FIELD MODIFICATION FORM
FOR
CORNELL DUBILIER ELECTRONICS SUPERFUND SITE: OU4 BOUND BROOK
THE LOUIS BERGER GROUP, INC.

DATE: April 5, 2012 (revision 1)

DOCUMENT: Quality Assurance Project Plan
Cornell Dubilier Electronics Superfund Site: OU4 Bound Brook

ACTIVITY: Field Modification No. 7
Modeling Data Needs

Figure 2

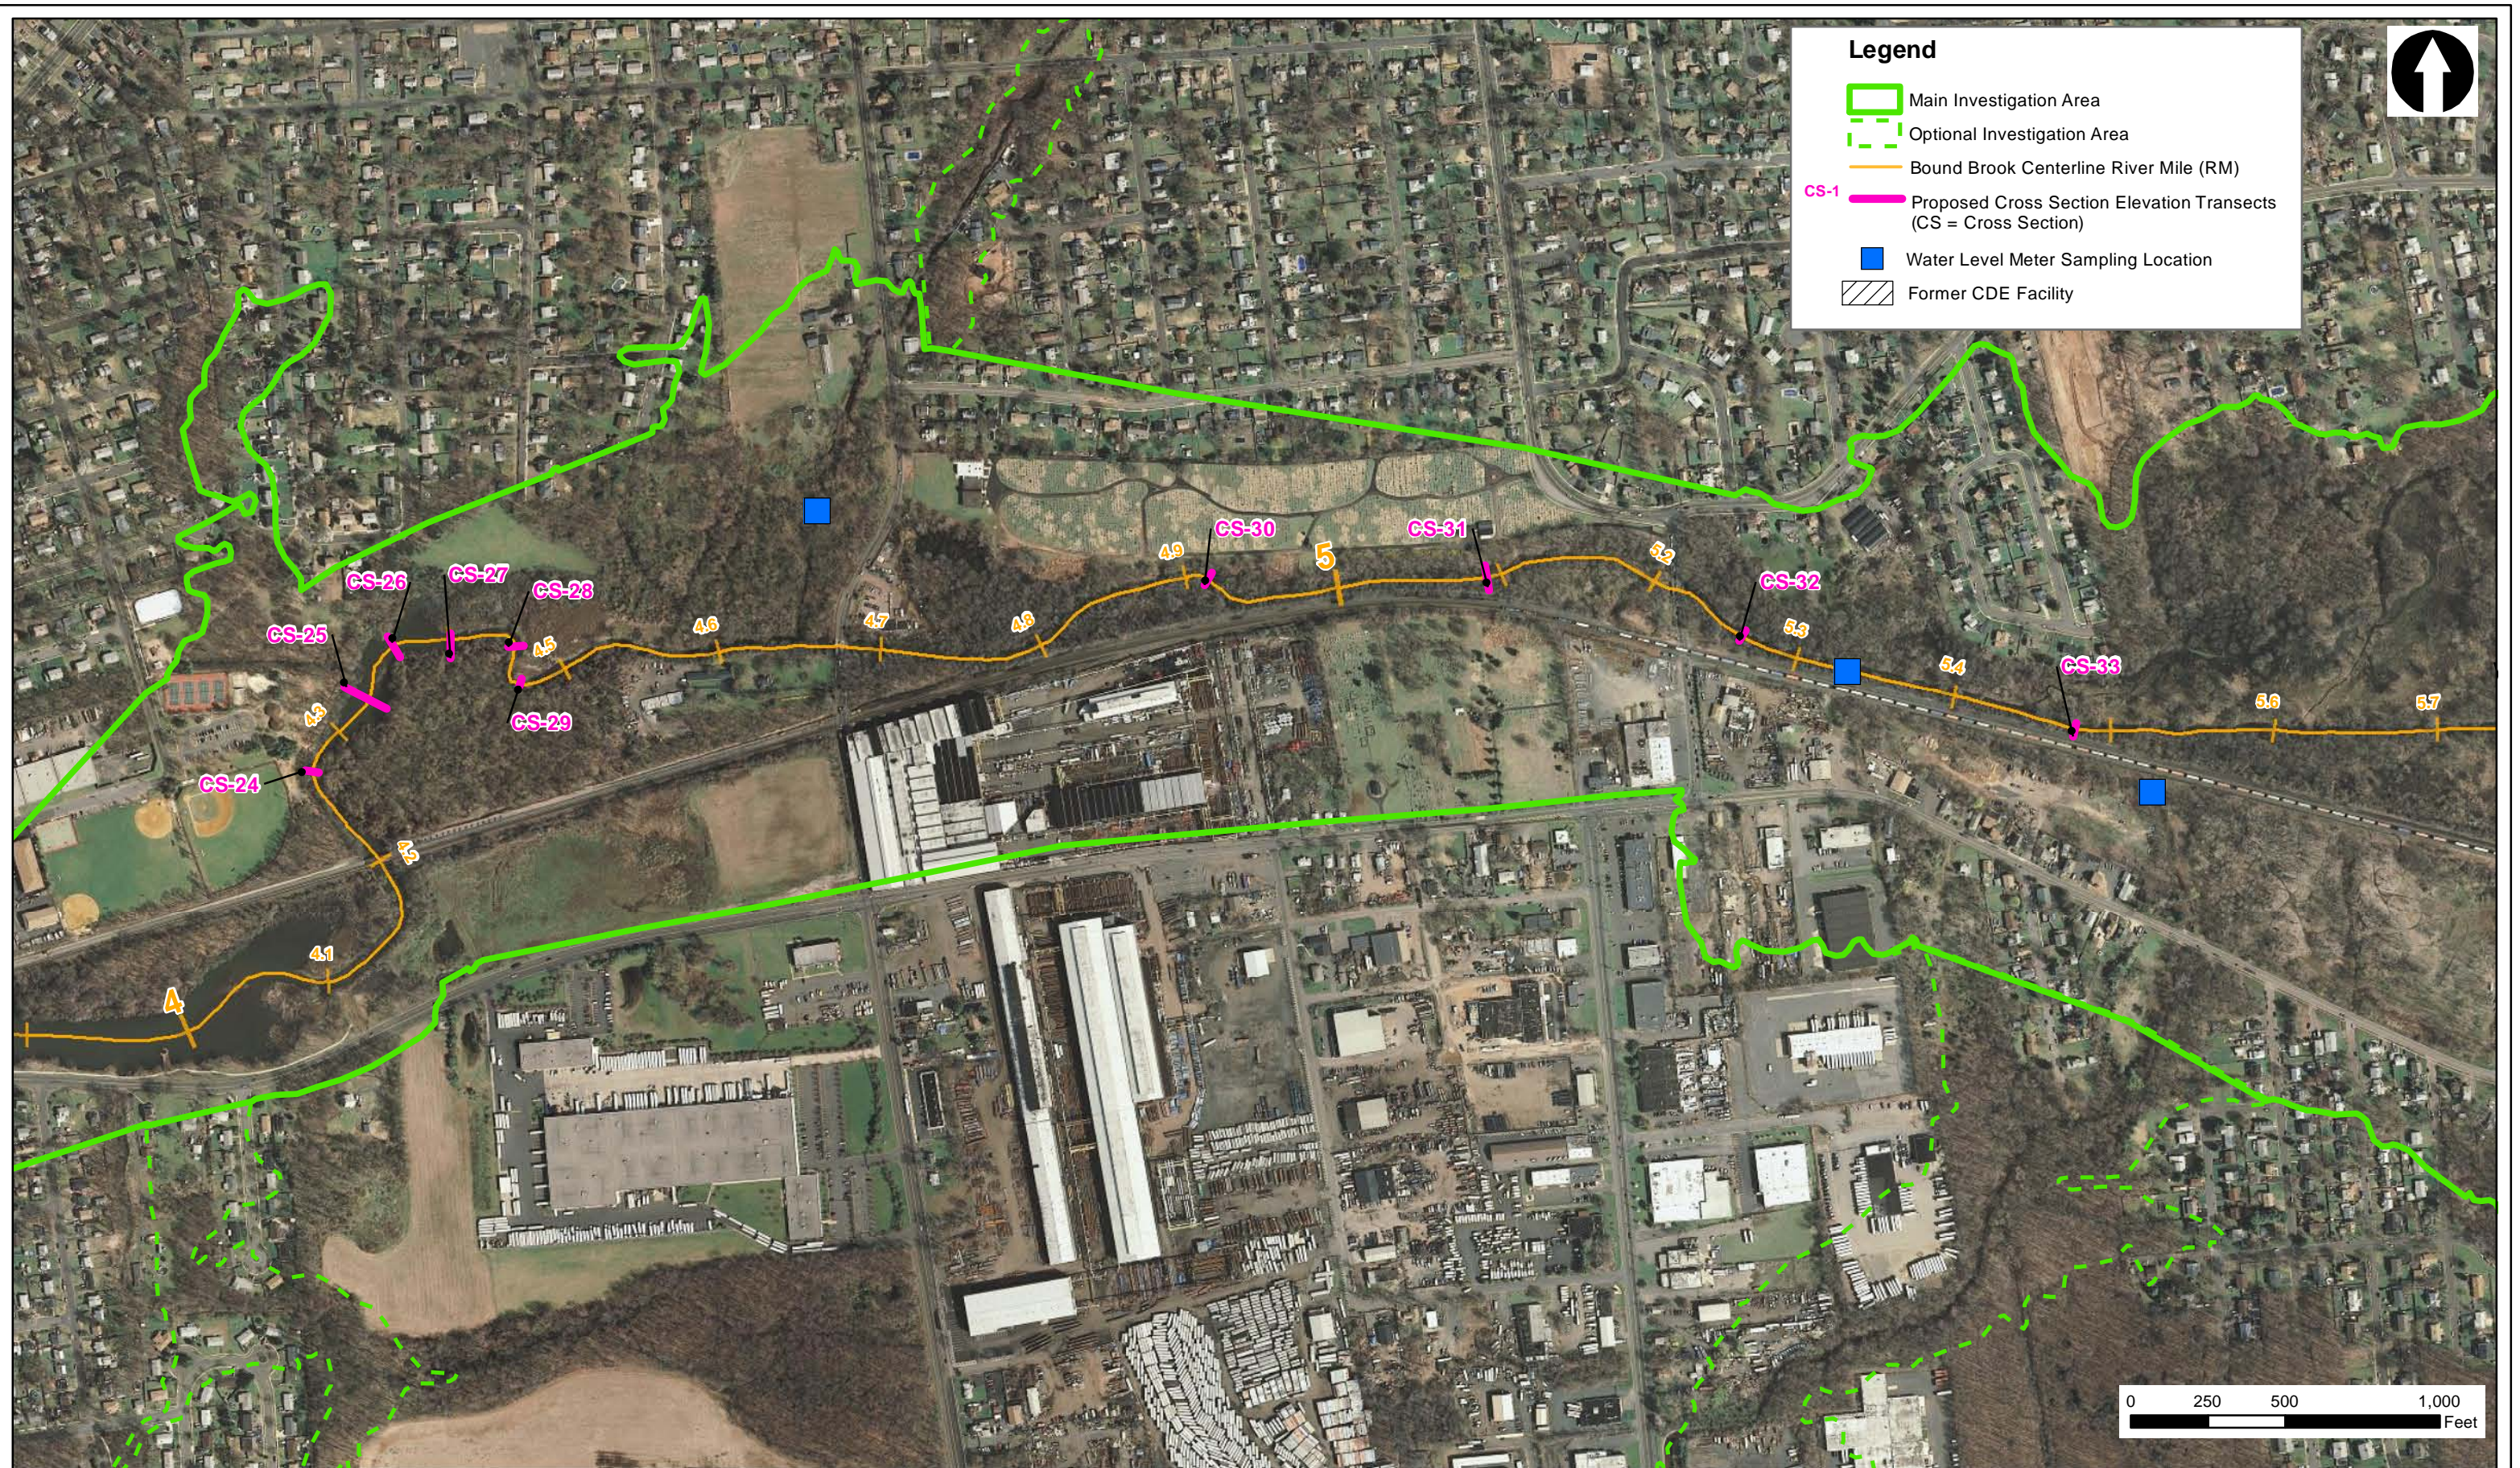
Figure: Cross-Sectional Elevation Locations (to be surveyed)

¹ Figure 4 of QAPP Modification No. 1 presented “proposed” and “optional” cross-sectional elevation locations. Field Modification No. 7 provides the final transect locations that are being surveyed in winter 2011.
